ITEM: 6.8	REPORT SUMMARY MINOR VARIANCE APPLICATION FILE NUMBER A023/26
------------------	--

MINOR VARIANCE APPLICATION FILE NUMBER A023/26

CITY WARD #:	1
APPLICANT:	Nadia Lazzarino & Phillip Lazzarino
AGENT:	RN Design Ltd.
PROPERTY:	25 Pennon Road, Kleinburg
ZONING DESIGNATION:	See below.
VAUGHAN OFFICIAL PLAN (2010) DESIGNATION:	Vaughan Official Plan ('VOP 2010'): "Low-Rise Residential"
RELATED DEVELOPMENT APPLICATIONS:	None
PURPOSE OF APPLICATION:	Relief from the Zoning By-law is being requested to permit a proposed cabana in the rear yard.

PROJECT/LOCATION: CABANA PROJECT
25 PENNON ROAD, VAUGHAN

GROUND FLOOR PLAN

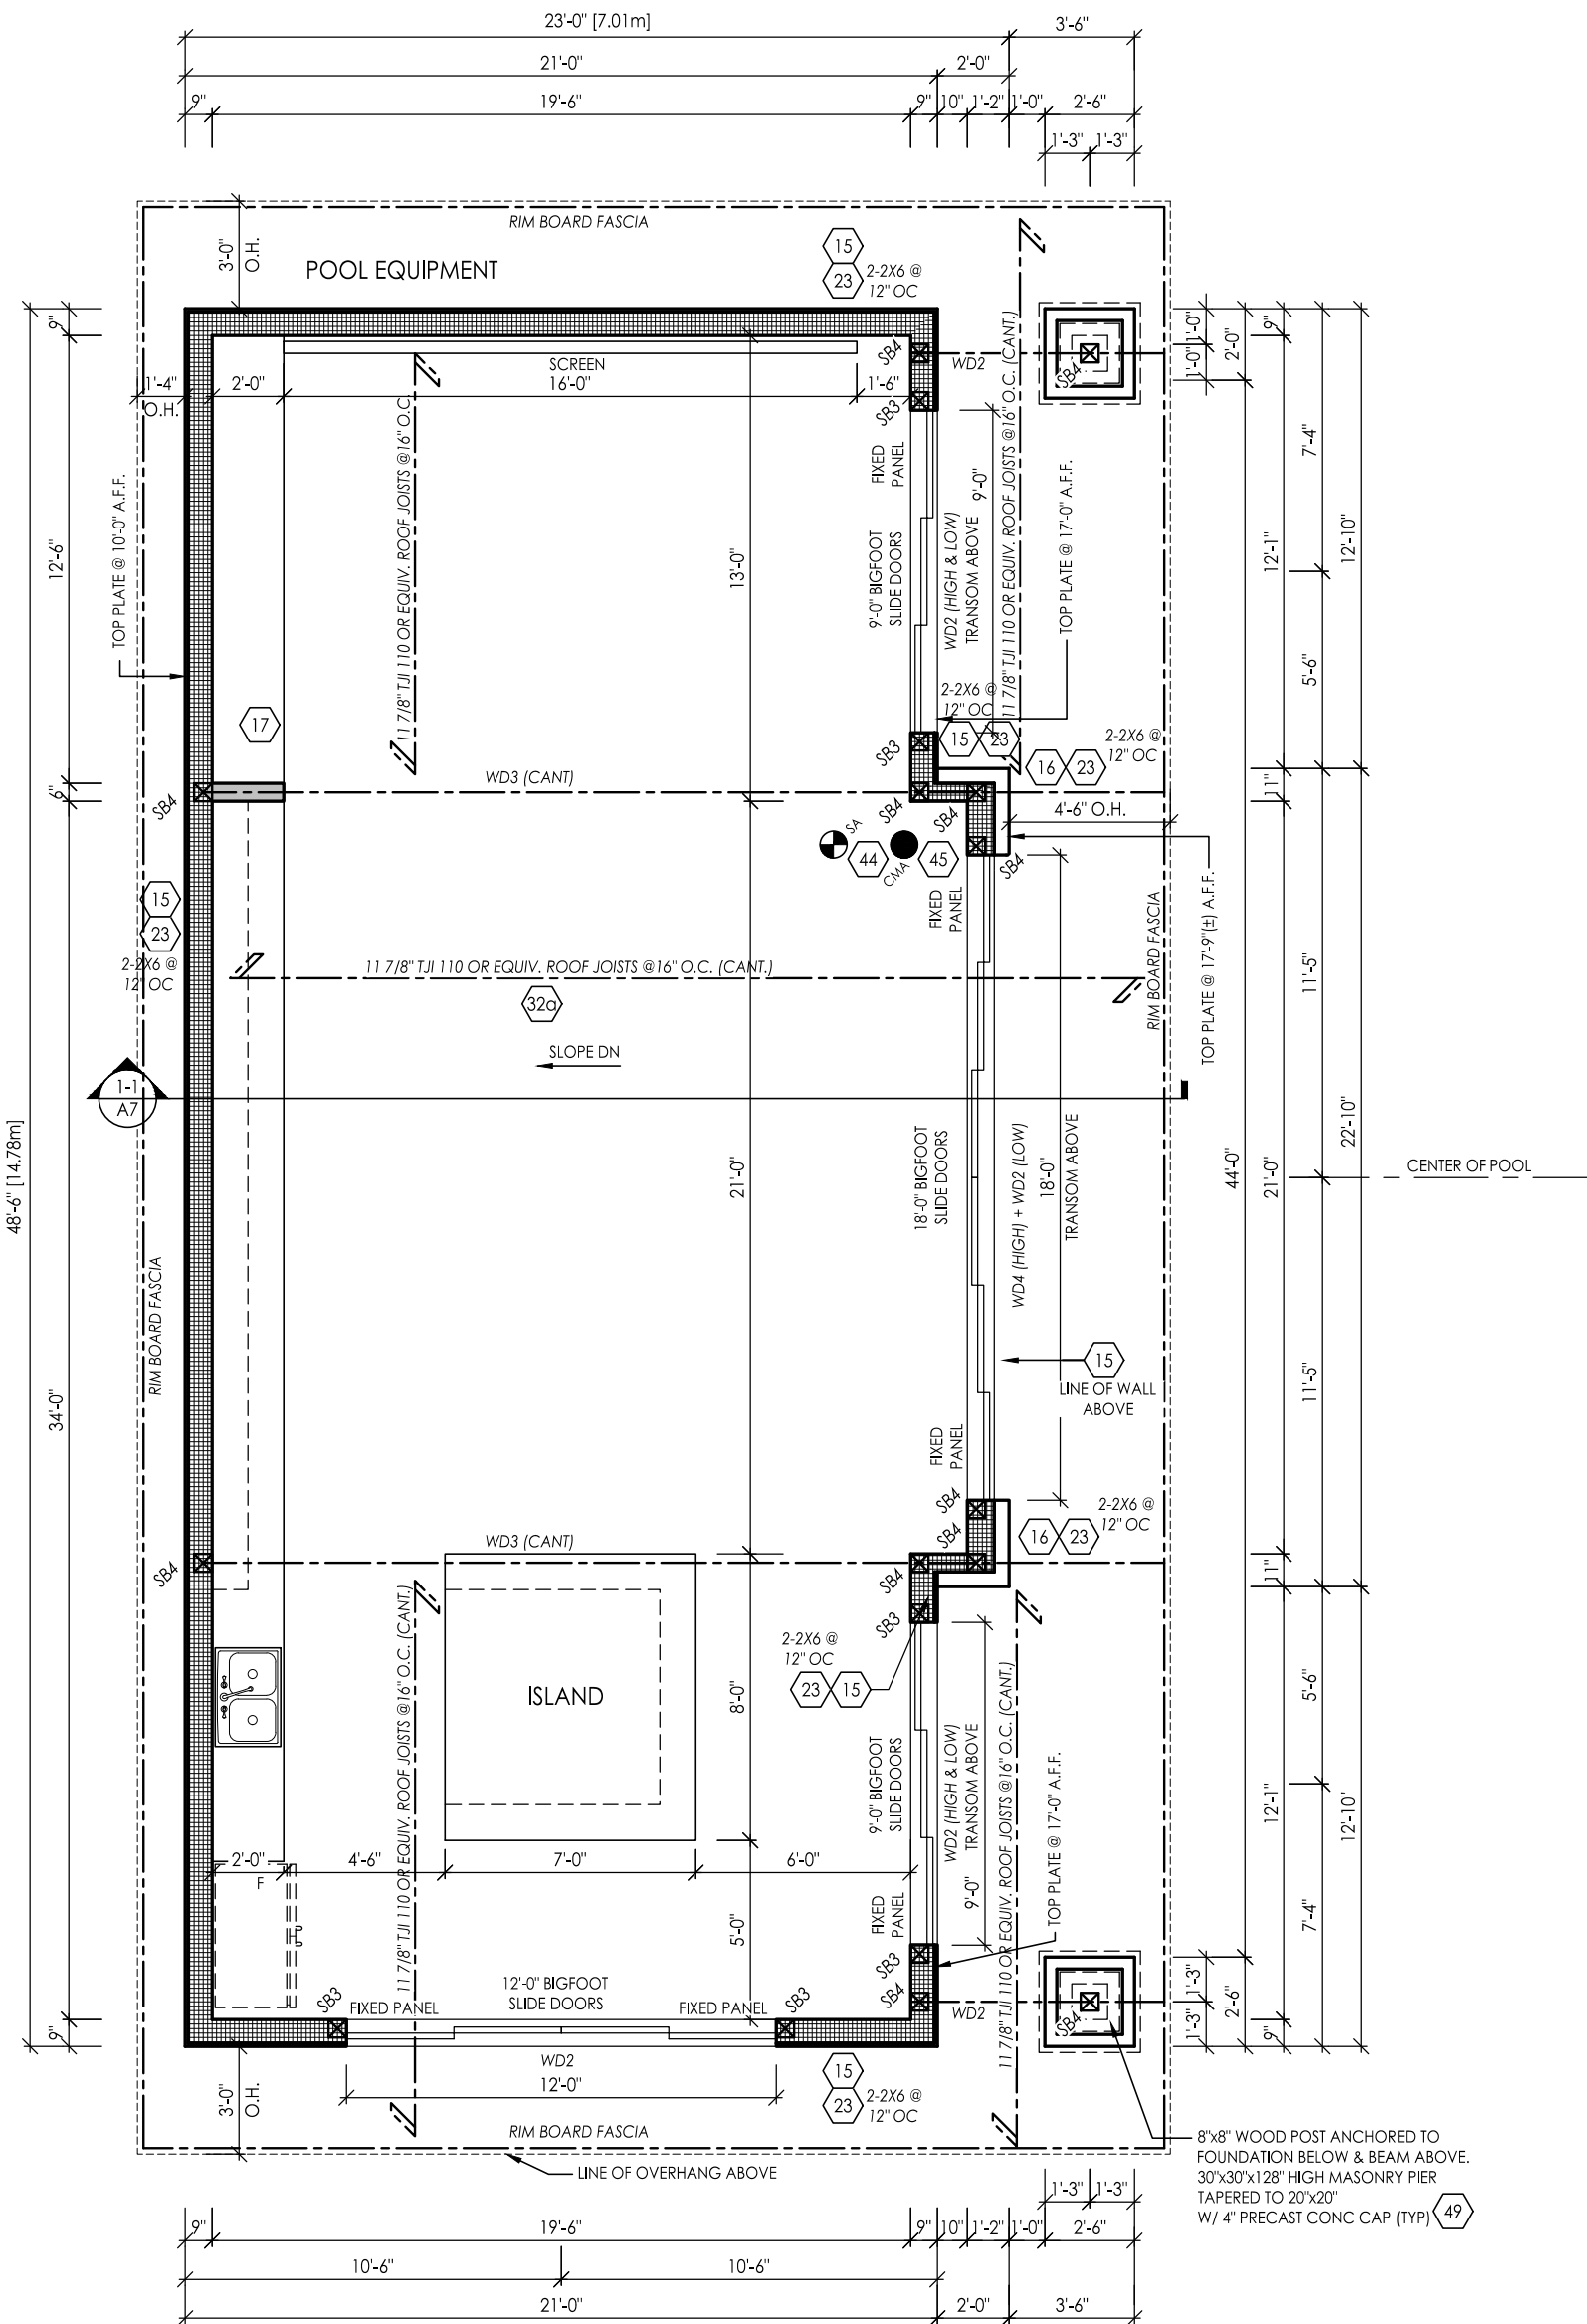
Floor Area: 98.86m2 (1064.17 ft2) **VARIANCE #2**
